Access Compliance Report

Public Rights-of-Way

(Curb Ramps)

Intersection ID: 10027881	Main Street: HAMPSHIRE_HILL_RD	Cross Street: N/A	Location:	S
ADA ID: 837290483212	Ramp Type: BlendTrans2	Initial Pass/Fail: Pass	Overall Compliance: No	Severity Score: 2.5
Codes/Mitigation Info/Possible Solution		Field Measurements/Component Compliance

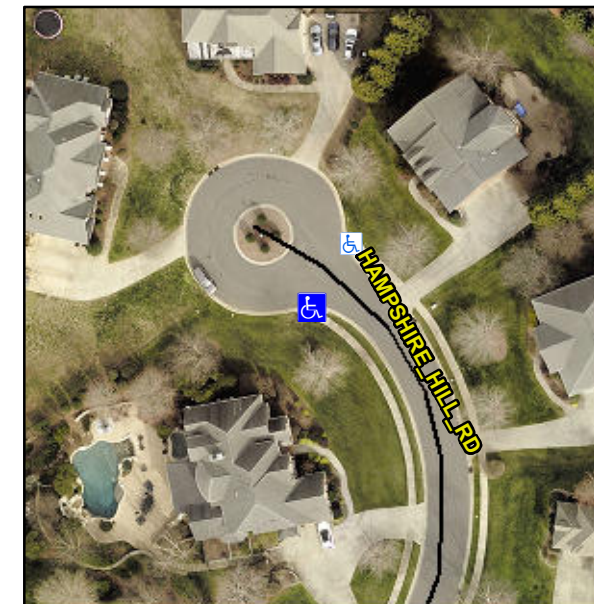
Remove & Replace Detectable Warning System. Remove & Replace Gutter.

R305.1.4, R305.2, R304.5.3
